RE: **Palen Solar Power Project, Docket No. 09-AFC-7**
Responses to January 14, 2010 CEC Workshop Queries
Technical Areas:
Soil & Water Resources (supplemental data for DR-S&W-242)

Palen Solar Power Project

Soil and Water Data Responses to January 14, 2010 CEC Workshop Queries

DR#242 Supplemental---Soil and Water:

30% Conceptual Engineering Plans
NOT FOR CONSTRUCTION
DATED: January 28, 2010

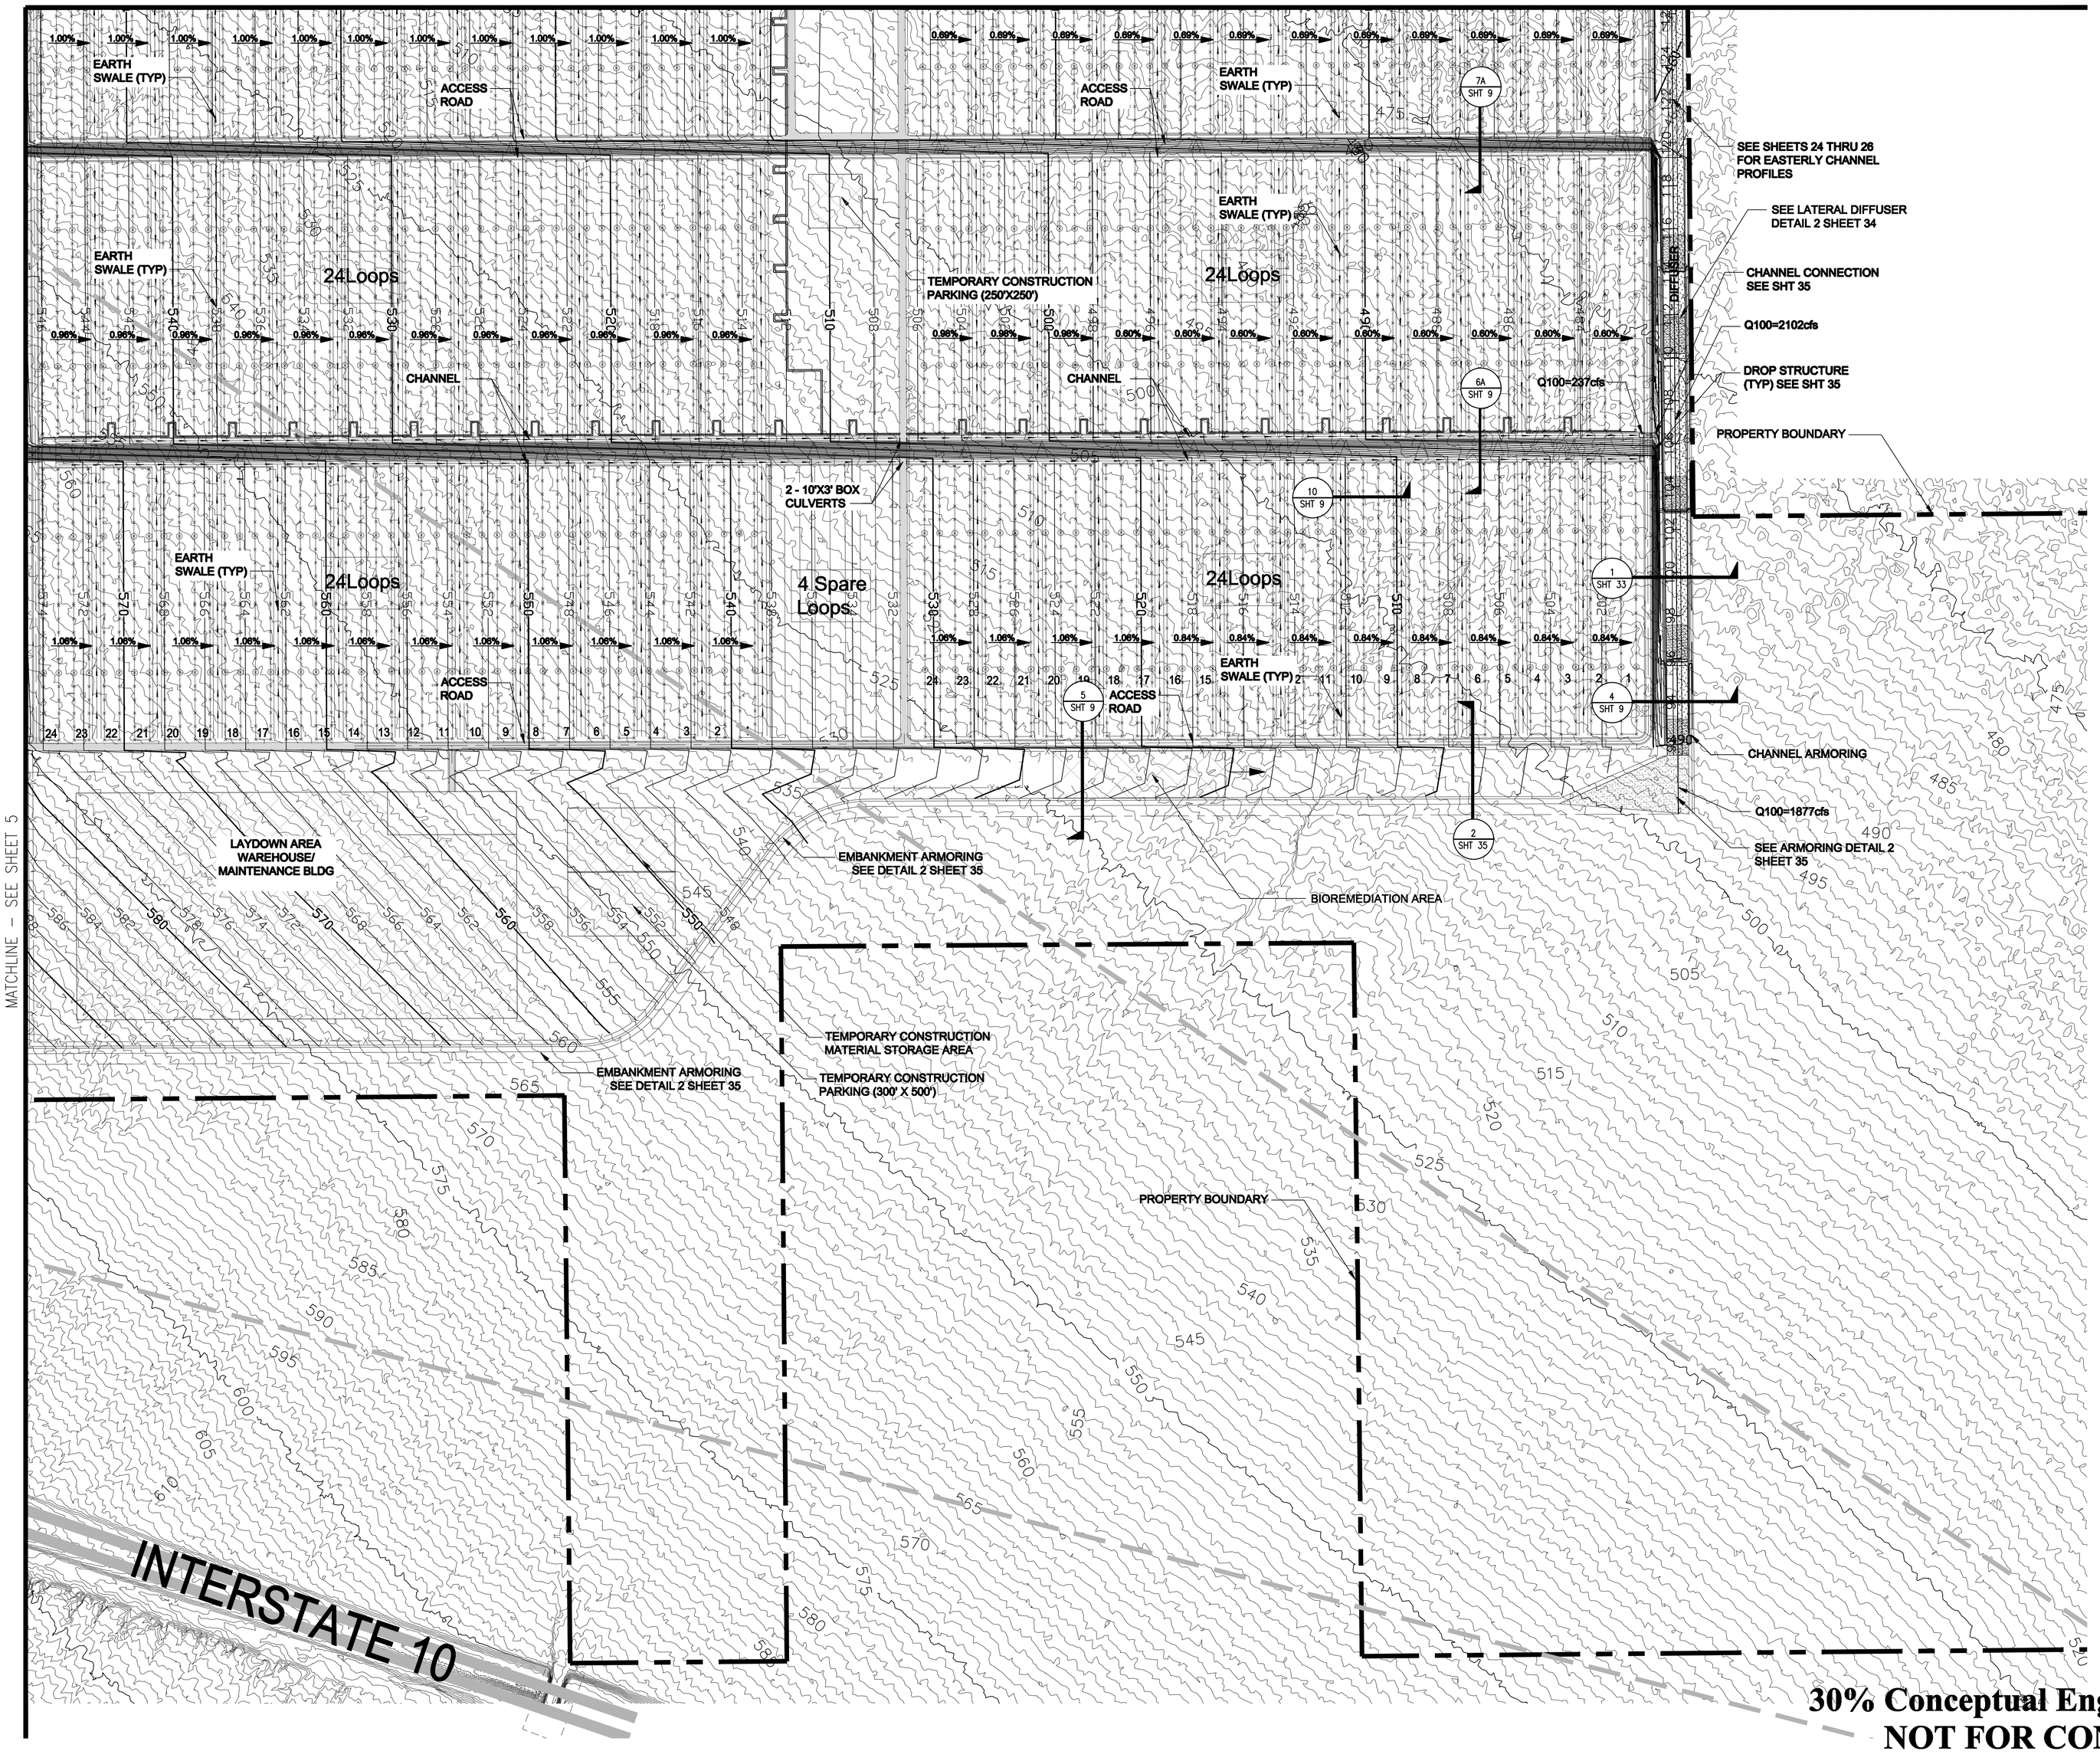
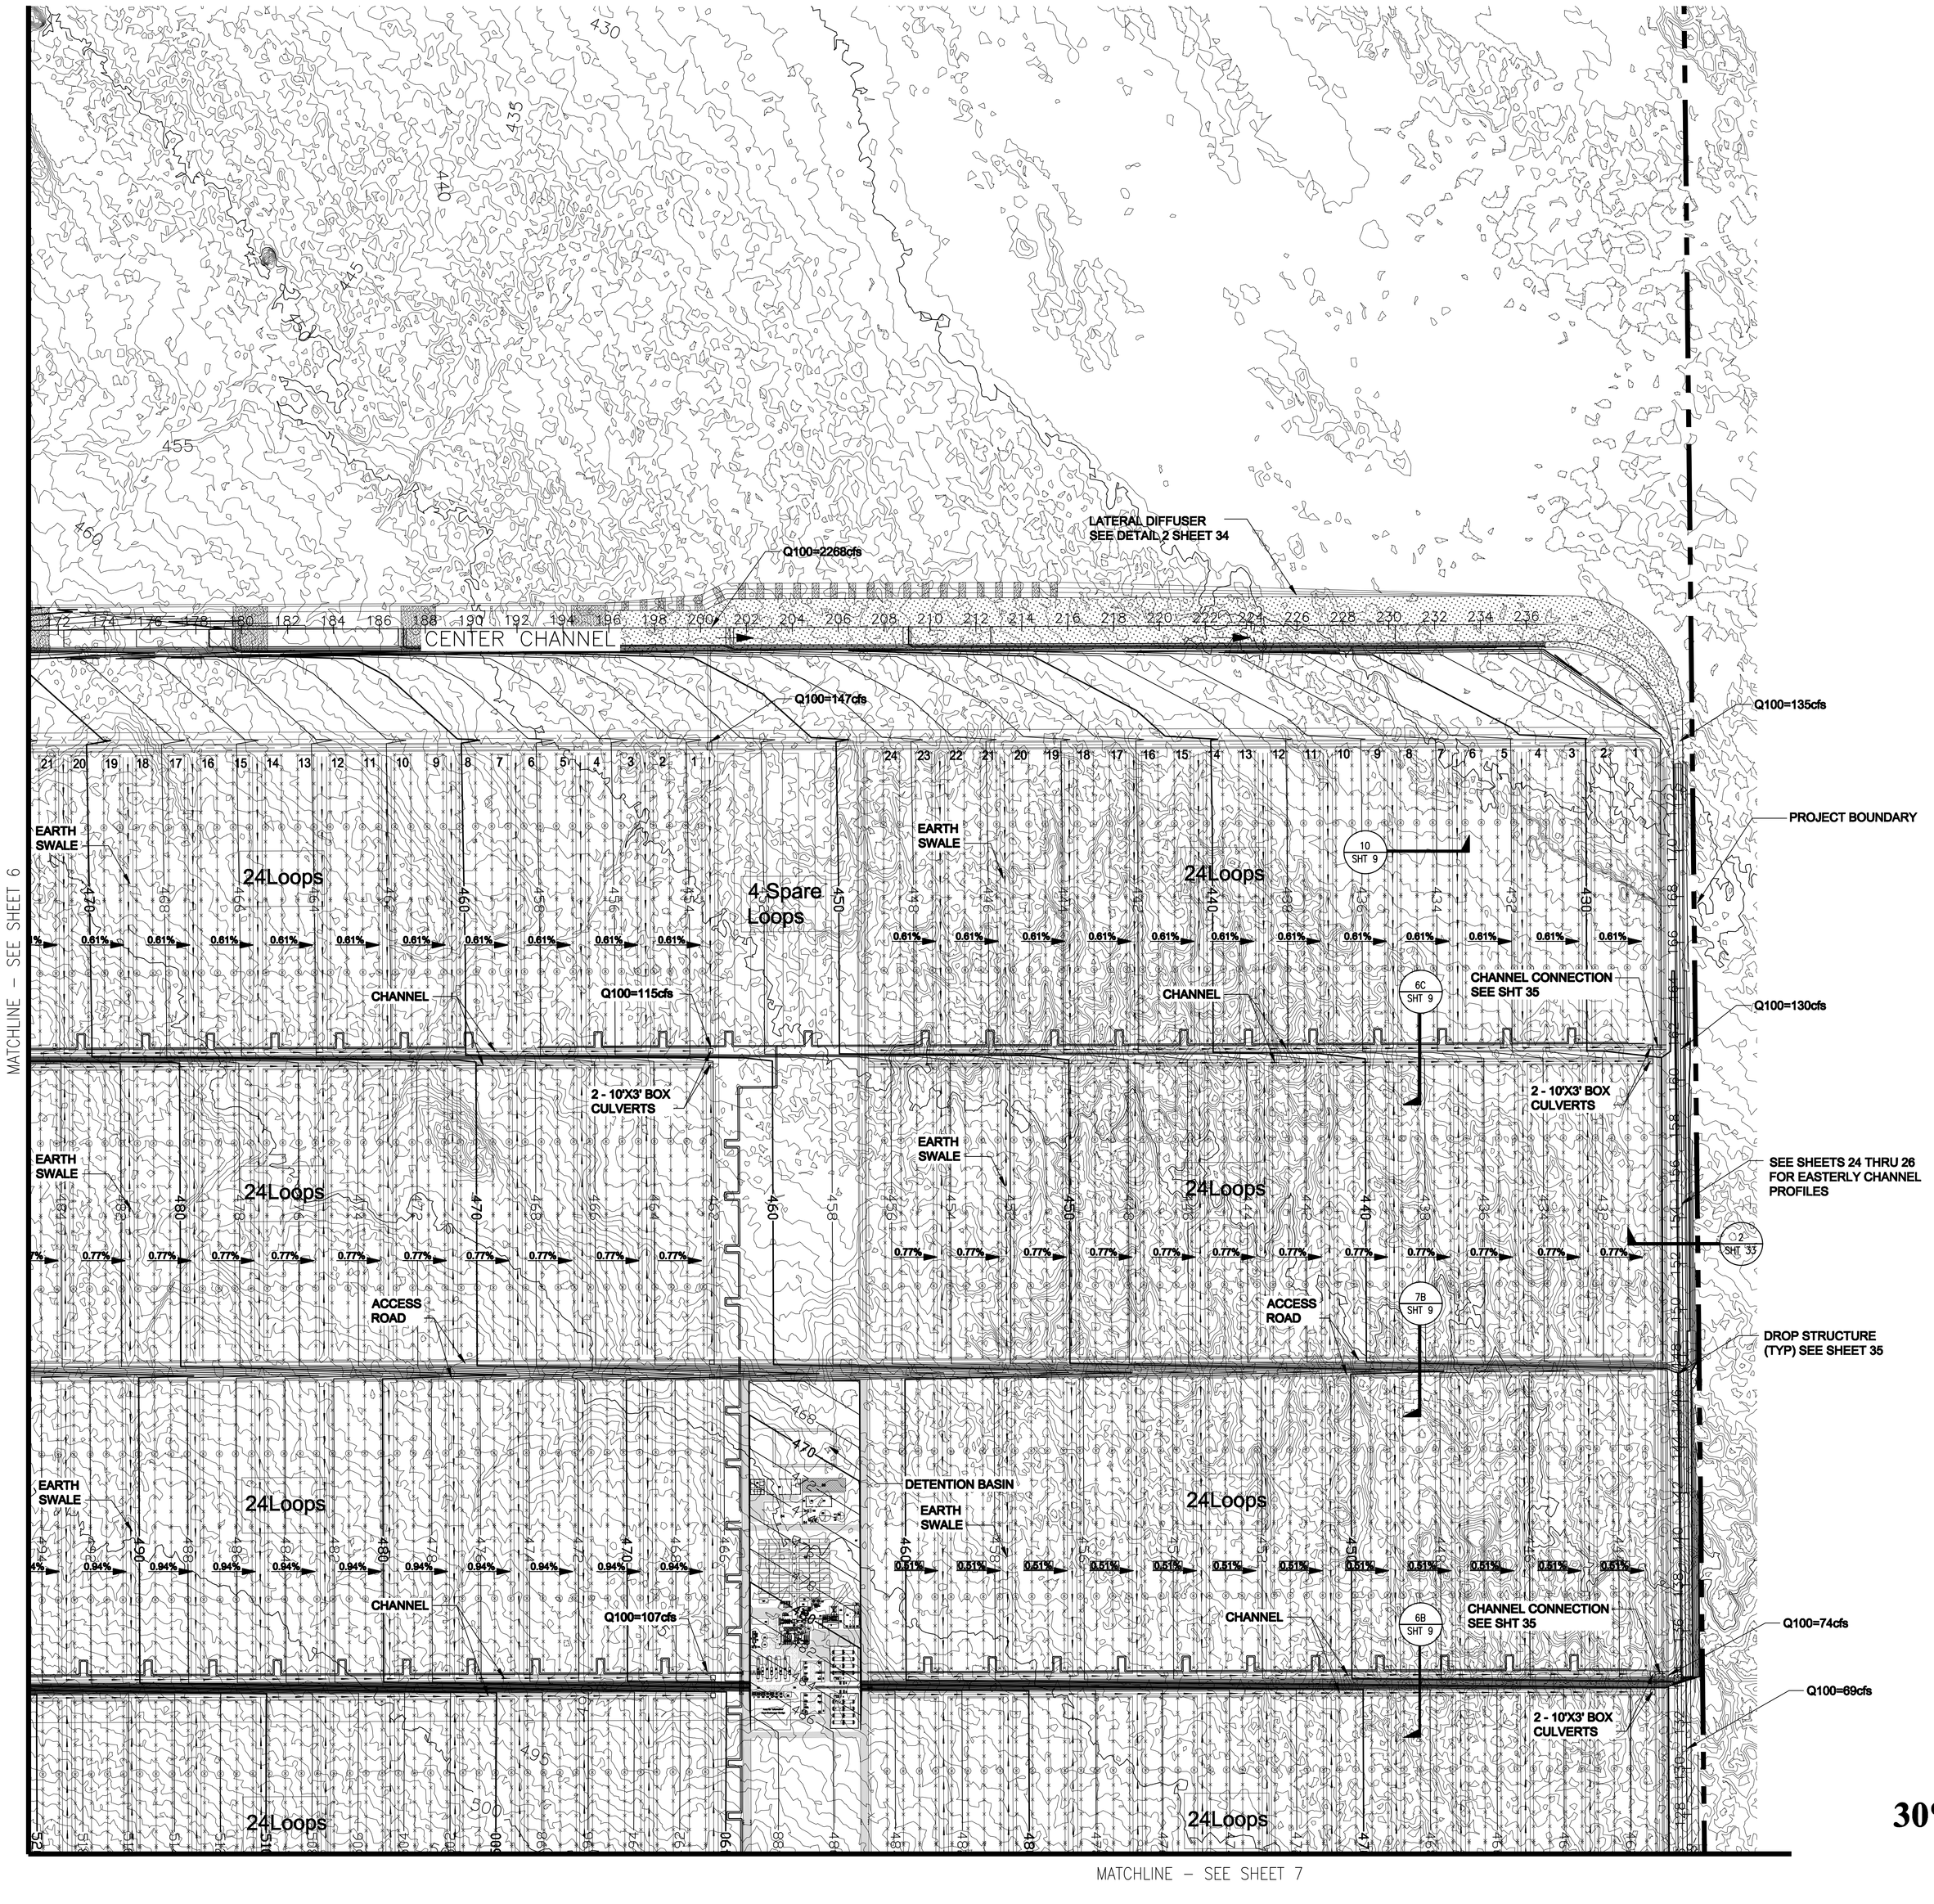
Add channel stationing on plan view drawings to match channel profile drawings (DR-S&W-242).

Add 1 ft contours to Palen post-development drainage drawings; drawings currently show only 5 ft contours.

Channel stationing is being added to the plans and will be provided as part of this response. Channel stationing is shown on the grading sheets 5-8.

The 1-foot contours have been added to the plans and are being provided as part of this response. The contours are shown on sheets 5-8.
